## **REMARKS**

Application Number 09/714,325 Amendment dated September 3, 2004 Reply to Office Action of June 3, 2004

Fig. 4

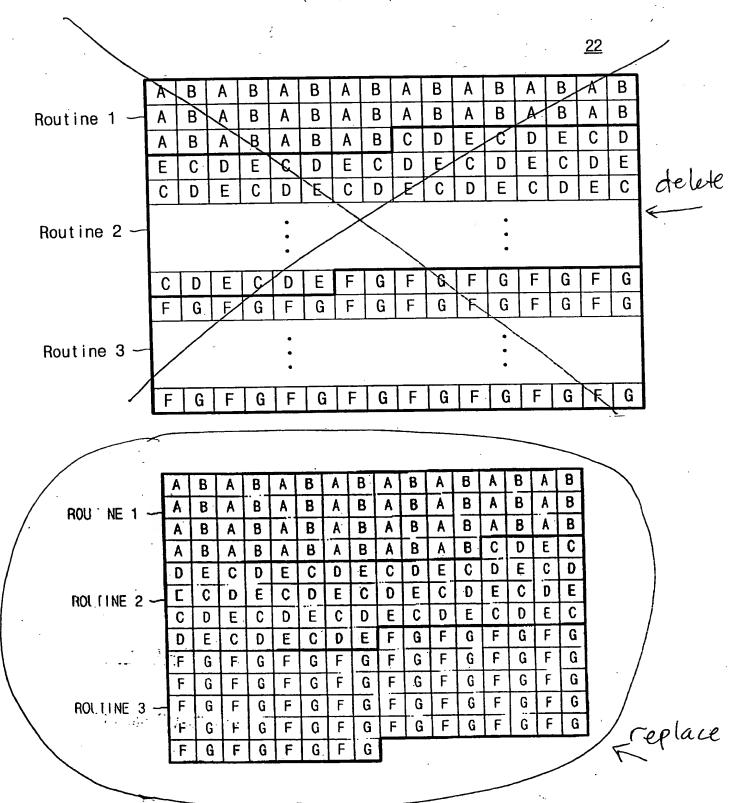
The drawings are objected to for informalities. Regarding the objection to Figures 3 and 4, Figure 4 is amended to show that in Routine 1 instructions A and B are both executed 40 times. Also, Figure 5 is amended to replace "Current Access Loop Counter" with "Current Loop Iteration Counter" and to replace "Old Access Loop Counter" with Total Loop Iteration Count." Reconsideration of the objections to the drawings is requested. With regard to the objection to Figure 9, the reference numeral 230 has been changed to 220 to indicate the address trace cache in accordance with the invention. In view of the amendments to the drawings, it is believed that all objections to the drawings are overcome, and reconsideration is requested.
